| 3 X 800 MW PATRATU STPP                                   |  |   |
| COMPLIANCE REPORT   |  |   |
| CPU REGN BLDG- GA & RC DETAILS OF FOUNDATIONS & PEDESTALS |  |   |
| Drg. No.: 9585-001-315-PVC-C-0616-00                      |  |   |

FOUNDATION AND PEDESTAL LAYOUT

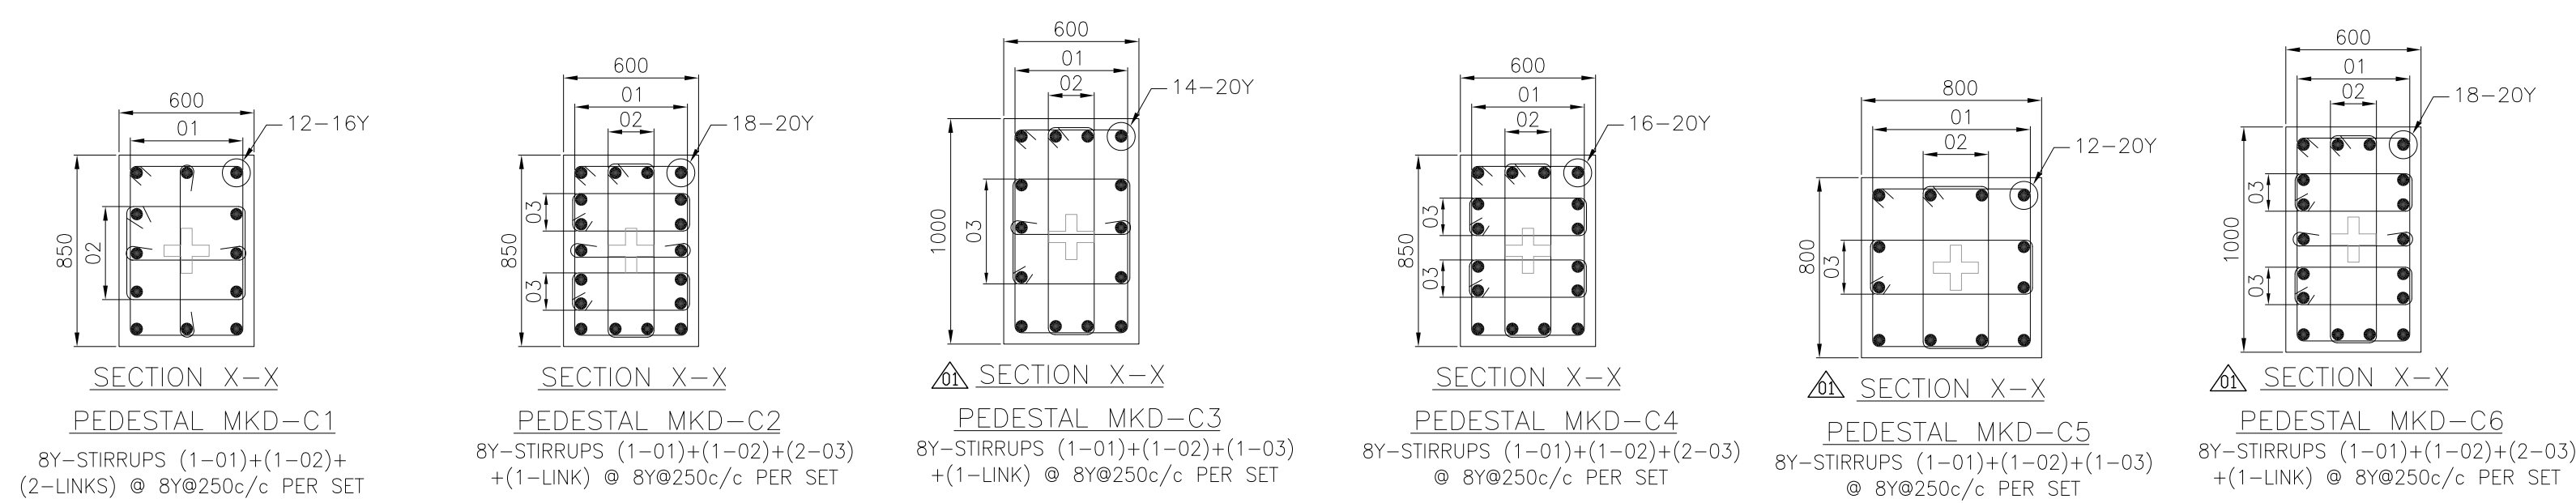
| 3 X 800 MW PATRATU STPP                                   |  |   |
|---|--|---|
| 1   | As per approved geo-technical report, founding level is EL(-)0.5m and net SBC is 30 T/sqm.<br>Please check and revise. | Please note that as per approved geotechnical report and as per location of CPU regeneration building in latest plot plan, the nearest bore hole is BH-134. Accordingly, Net SBC considered for foundation design of CPU Regeneration Building is 30T/sqm at 2m depth below FGL (refer page 97/230 of approved geotechnical report). Drawing and design of foundation has been revised as per same. Please note that due this revision there is no change in foundation size & reinforcement details. |

7. NET SBC CONSIDERED IS 30T/SQM. AT FOUNDING LEVEL AT EL.(+/-)0.50M
8. FOR CLEAR COVER TO OUTERMOST REINFORCEMENT (INCLUDING TIES) REFER STANDARD DRG NO. 9585-001-315-PVC-C-0451B.

Founding level of minimum 0.5m embedment in to the rock shall be ensured at site
